CERTIFICATE OF APPROPRIATENESS

Property: 1913 A Crockett St, Lot 11A, Block 314, Crockett Street Landing Subdivision. The property is a vacant lot, subdivided into two lots – 1913-A, which fronts on Crockett St, measures 2,534 square feet (51’ x 50’-4”); 1913-B at the rear is 1,608 square feet (37’-8” x 42’-8”).

Proposal: New Construction – Residence

Construct a 2,310 square foot two story residence and attached garage.

BLOCKFACE RENDERING – FRONT FACING CROCKETT STREET

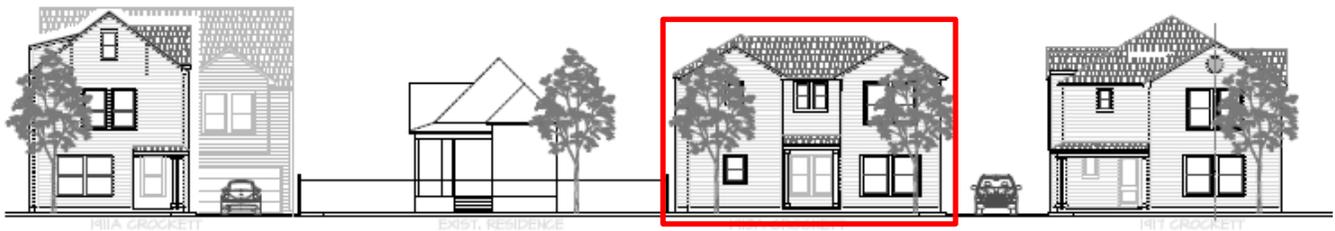
Staff comment: This drawing from the applicant does not reflect an accurate distance between the one-story contributing house at 1907 Crockett and the proposed structure. With only a 1' side setback, the new house will have less than 4' separation from 1907 Crockett.

EAST SIDE ELEVATION

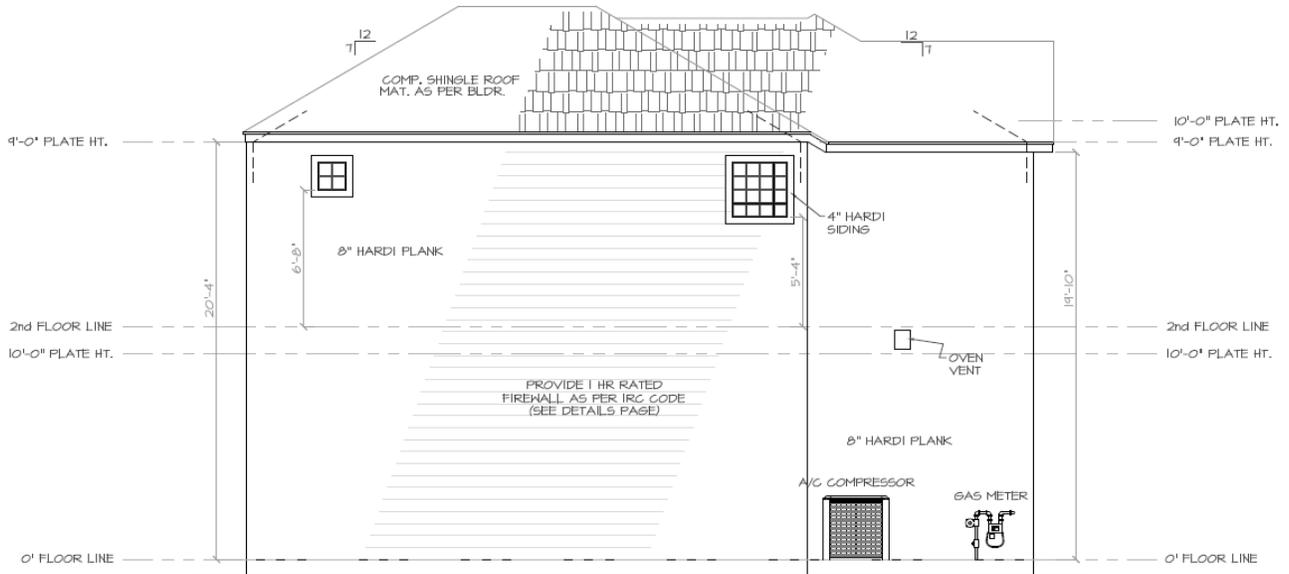
The draft Design Guidelines also require traditional solid-to-void proportions for walls to windows. The east and west elevations visible from the street lack window openings, which is not in keeping with typical contributing structures in the area and therefore does not meet this provision.

SITE PLAN
EXISTING

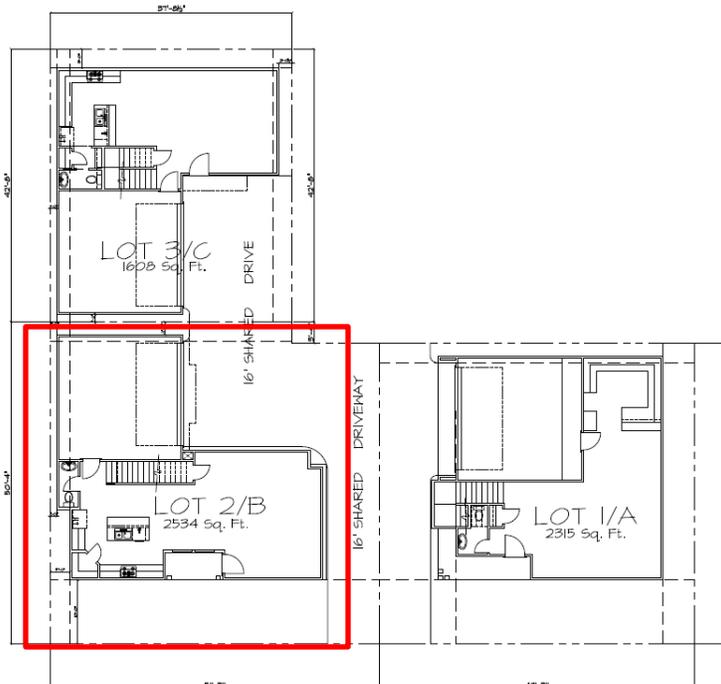
- 1.4. The historic/contributing structure at 1907 Crockett is known to encroach on its neighbor to the west (1913 Crockett). This encroachment is not shown on the site plan. This omission is significant, since it affects the actual distance that will separate the new structure at 1913 from the existing one at 1907.

- 1.5. A 10' setback from the street is noted. This is out of character for the District, where setbacks of 15 feet or more are prevalent on contributing structures. Is this permissible?
